# CI 104 Maintenance – Vpse clarification and MDI faults

G. Zimmerman/ADI, APL Group, Cisco,  
CommScope, Marvell, SenTekSe

6/15/2021

Figure 104-3—PoDL system block diagram

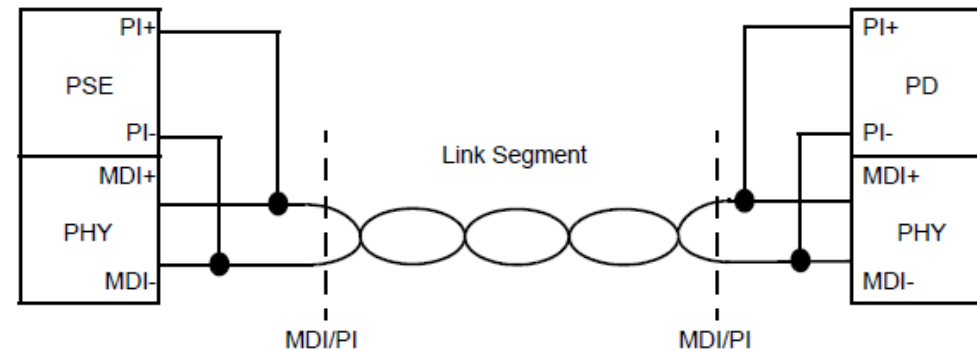
# Issue: Vpse & Vpd are each across the pair

We assume it but don't say it.... IEEE 802.3bt eliminated the definitions in 1.4 for VPSE and VPD, and put them in clause 145 in a similar section to 104.3 where there is a table similar to Tables 104-1 & 1a in 104.3.

- The proposed text is in the PoE clauses, but absent in Clause 104
- This issue has caused confusion with the IEEE PES Surge Protection folks, thinking it could be conductor to shield, allowing > 60V across the pair

- We show it, but don't say it in text:

Proposed Change: Insert the following 2 new paragraphs after the last sentence in 104.3:

VPSE is the voltage at the PSE PI. VPSE is measured between any positive conductor and any negative conductor at the PI.

VPD is the voltage at the PD PI. VPD is measured between any positive conductor and any negative conductor at the PI.

Change the title of 104.3 from "Class power requirements" to "System Parameters"  
(same title as the similar section in .3bt)
